ESTERO TOWN CENTER CPD Amendment to Commercial Planned Development Zoning Staff Report <u>SUPPLEMENT</u> For Village Council

PROJECT NAME:	ESTERO TOWN CENTER CPD - A PORTION OF TRACT A, ESTERO TOWN COMMONS
CASE TYPE:	PLANNED DEVELOPMENT AMENDMENT
CASE NUMBER:	DCI2019-E005
COUNCIL 1 st READING:	November 18, 2020

DC12019-E005 Estero Town Commons Tract A (Firestone)

Director of Engineering: Brendan Sloan, P.E. (239-573-2077 or <u>Brendan@avaloneng.com</u>) November 6, 2020

BUILDING ELEVATIONS - (NORTH & SOUTH)

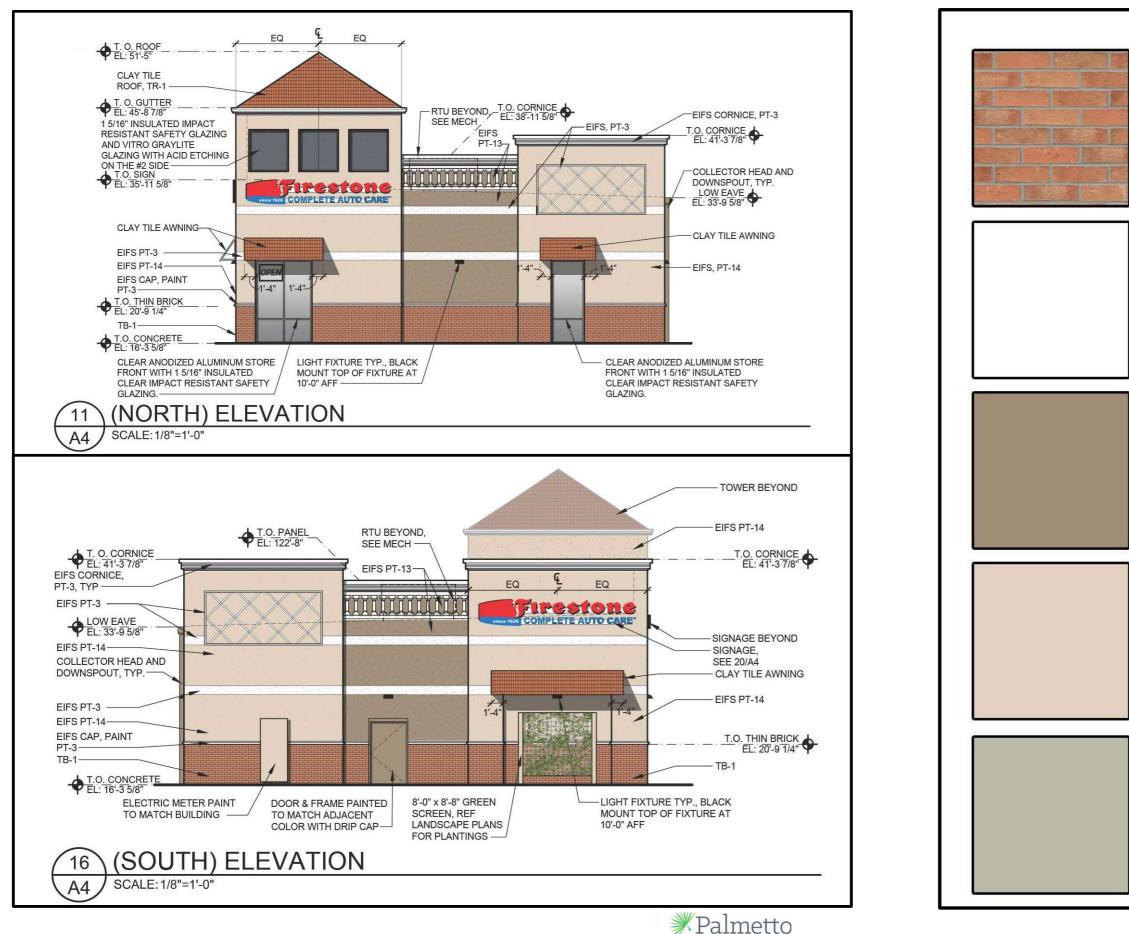
DETAIL 11 – (NORTH) ELEVATION

- 1. Revised main entrance glazing note to specify thickness of the impact resistant glazing. **(MC)**
- 2. Added top of roof elevation marker to coordinate with East elevation. (MC)
- 3. Added clay tile roof note to coordinate with note on East elevation. (MC)

DETAIL 16 - (SOUTH) ELEVATION

1. Added one 8'-0" by 8'-8" green screen to elevation. (OD)

BUILDING ELEVATIONS - (WEST)

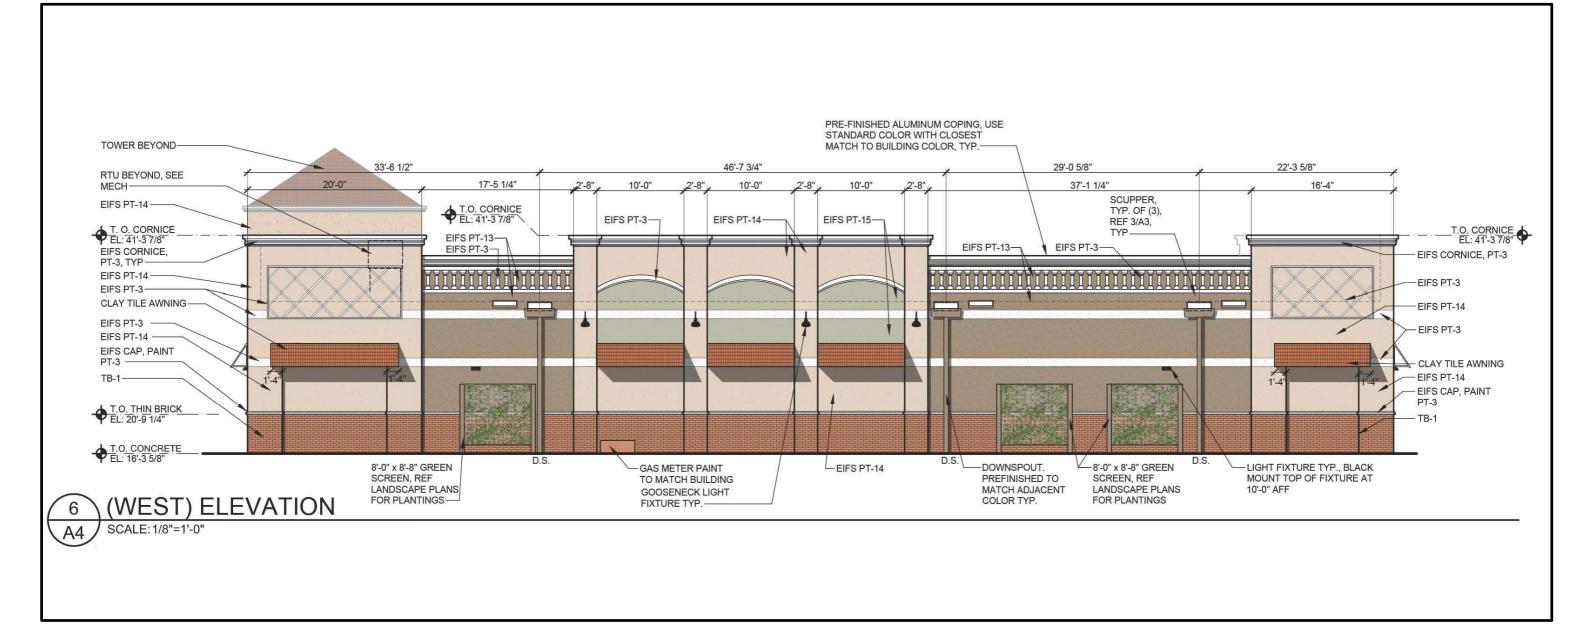
DETAIL 6 – (WEST) ELEVATION

- 1. Added white baluster cornice detail to elevation to coordinate with the other three elevations. **(OD)**
- 2. Added three 8'-0" by 8'-8" green screens to elevation. (OD)

> Pedestrian Amenity Corkscrew Rd & Three Oaks Pkwy

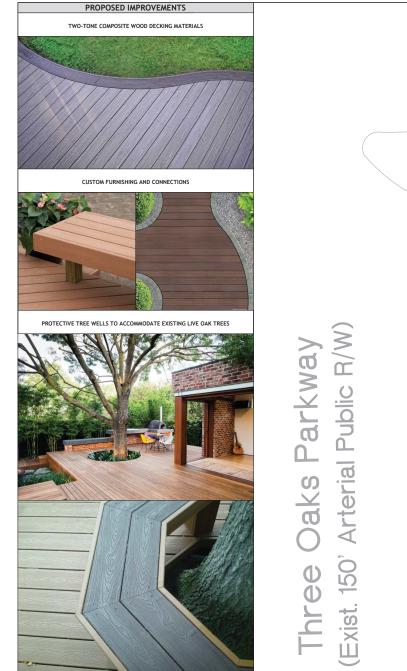
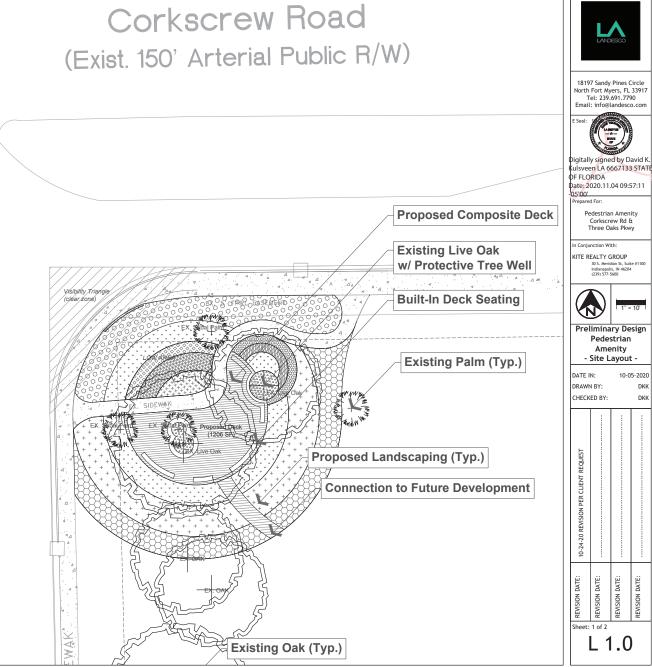
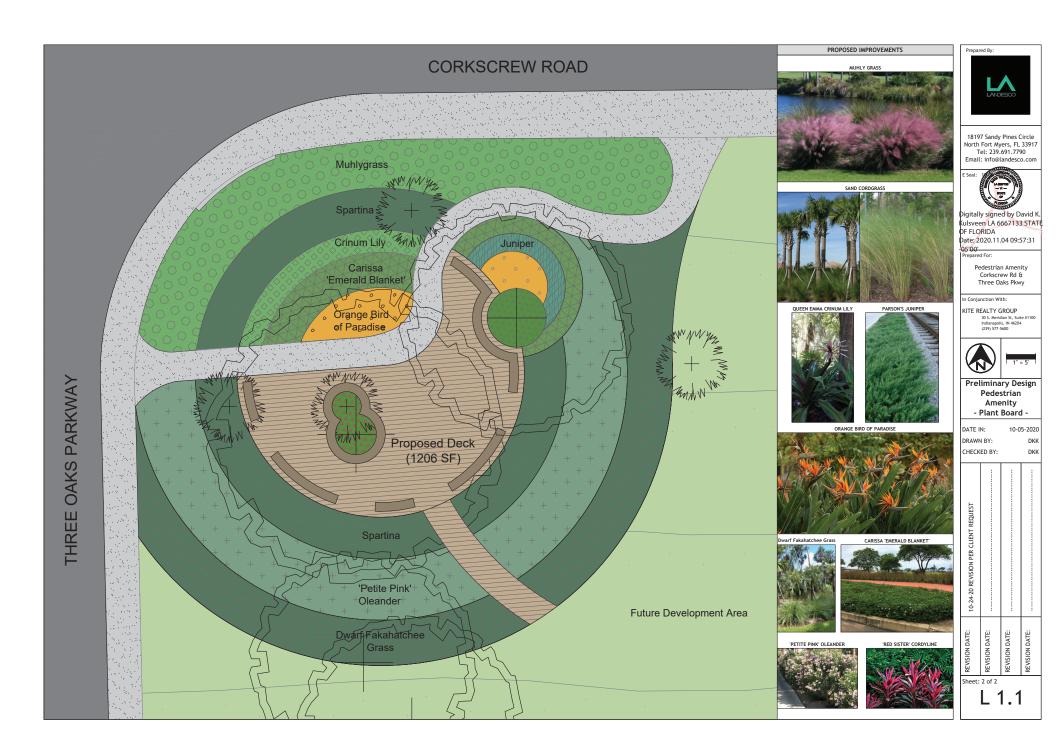
PEDESTRIAN AMENITY AREA

The existing pedestrian/open space area at the corner of Three Oaks Parkway and Corkscrew is proposed to be enhanced with a gathering area around the existing live oak trees. The gathering area will extend off the existing sidewalk that winds beneath the trees. The proposed plan consists of a circular composite deck, with benches and a pedestrian connection point to the future development area of Tract A. The live oaks will be pruned up to provide shade to the gathering area and will be protected by a tree well wrapping around the base of the trees. Additional landscaping will be planted around the deck in a complementary pattern to the gathering area. This proposal is in accordance with the Master Concept Plan and the Design Guidelines as outlined in the Approved Zoning Conditions incorporated into the Commercial Planned Development Resolution Number Z-03-032 for the Estero Town Center, now called Estero Town Commons.
